Model: BR-C1 (D179)		Date: 20-Aug-13	No.: RD179001
Subject: FSM Correction (Notes on main power switch status check / ITB unit removal procedure)		Prepared by: Kazuya Tsutsui	
From: 1st PP Tech Service Sec., PP Tech Service Dept.,			
Classification:	<input type="checkbox"/> Troubleshooting <input type="checkbox"/> Mechanical <input type="checkbox"/> Paper path <input type="checkbox"/> Product Safety	<input type="checkbox"/> Part information <input type="checkbox"/> Electrical <input type="checkbox"/> Transmit/receive <input type="checkbox"/> Other ()	<input type="checkbox"/> Action required <input checked="" type="checkbox"/> Service manual revision <input type="checkbox"/> Retrofit information <input type="checkbox"/> Tier 2

Correction 1

Installation > Installation Requirements > Main Power and Operation Power Switch > Operation Switch

Incorrect Drum Knob Position

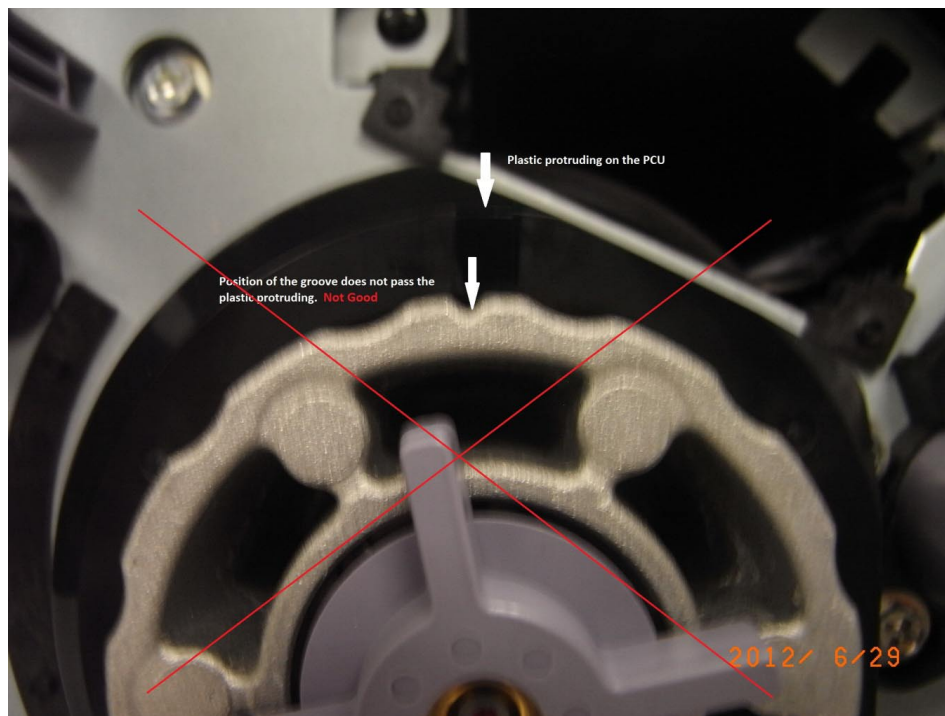
Correct Drum Knob Position

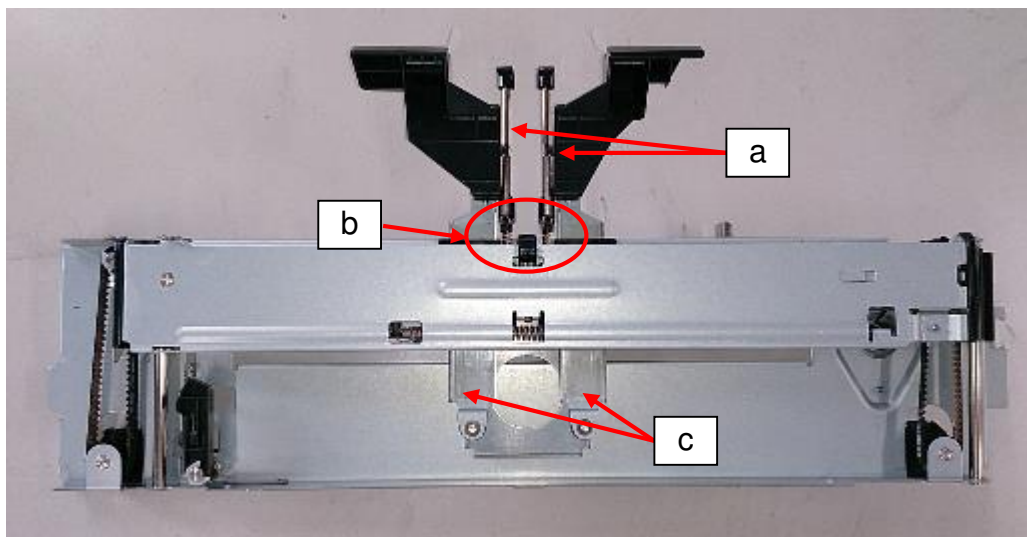
4. ~~Check if the paper holder plate (indicated in green below) slides smoothly.~~

~~If the plate slides smoothly, complete the procedure.~~

How to distinguish the original and modified lubricant bars

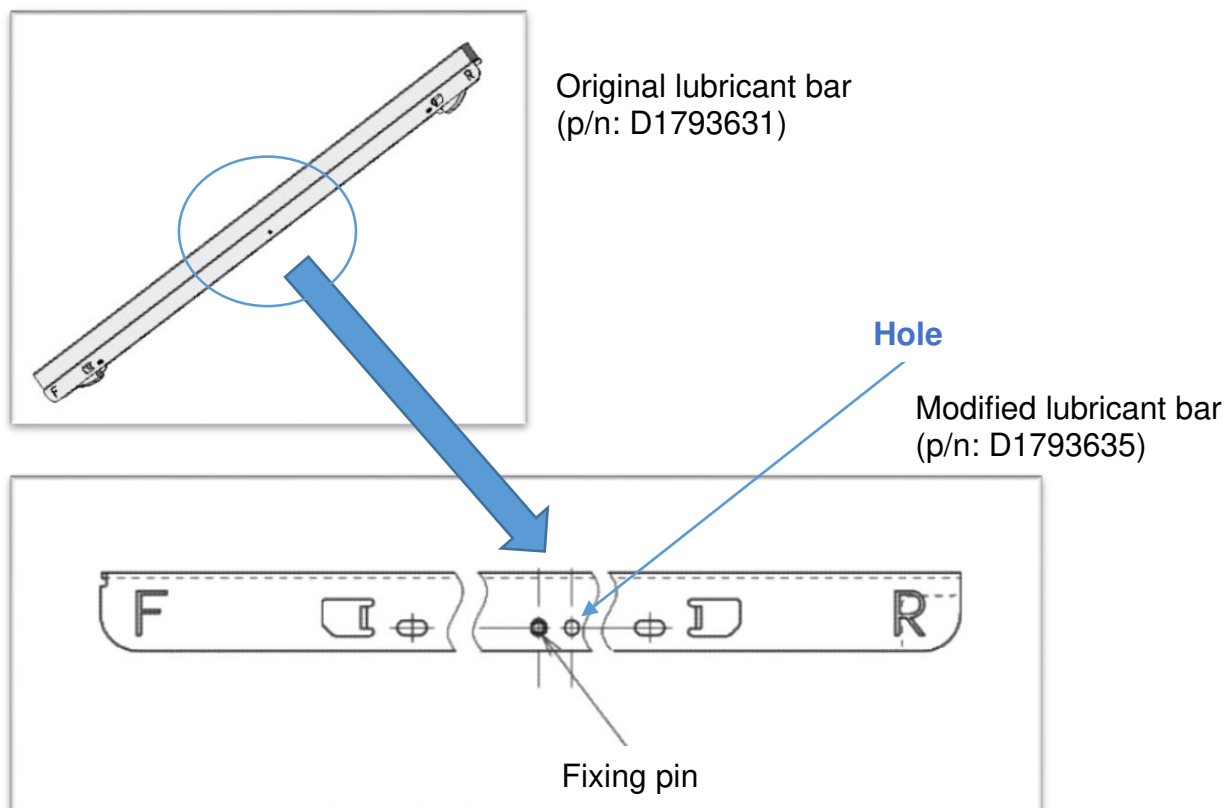
On the modified lubricant bar, there is a hole next to the fixing pin.

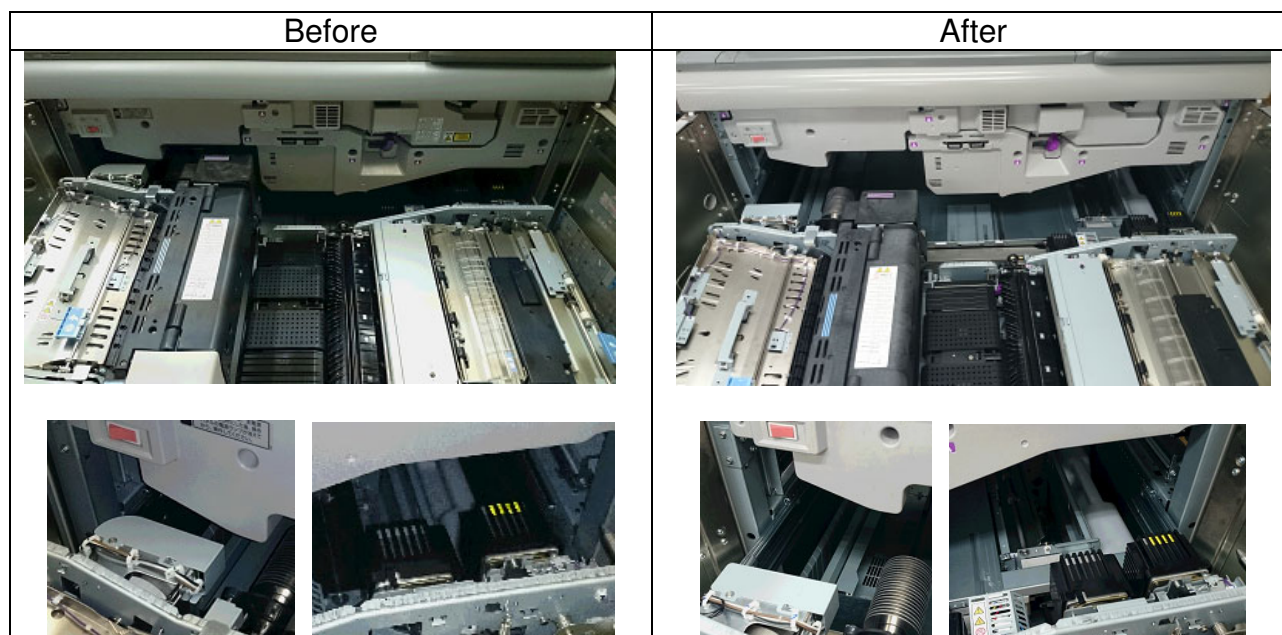
Old P/N	New P/N	Description	Q'ty	Int	Note
D1791105	D1791125	SLIDE RAIL:PULL OUT	2	X/O	Change

Reason: The slide rails of the drawer unit were extended 100mm for better reach inside the unit. The wider gap created between the unit and the frame enables easier jam removal.

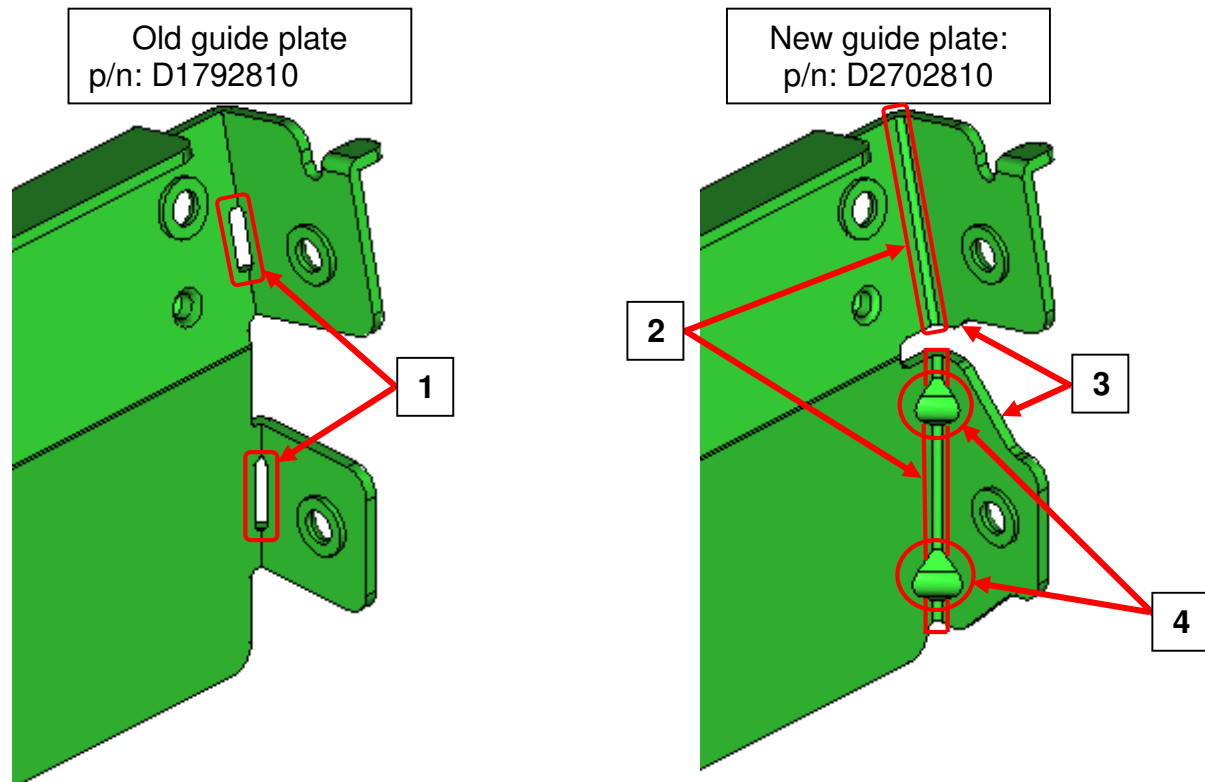
The following modifications were applied to the corner joints of the guide plate, to prevent breakage.

1. Eliminated the hole in the joint.
2. Optimized the angle of the joints.
3. Enlarged the joints.
4. Added a V-shaped wedge to the joints.
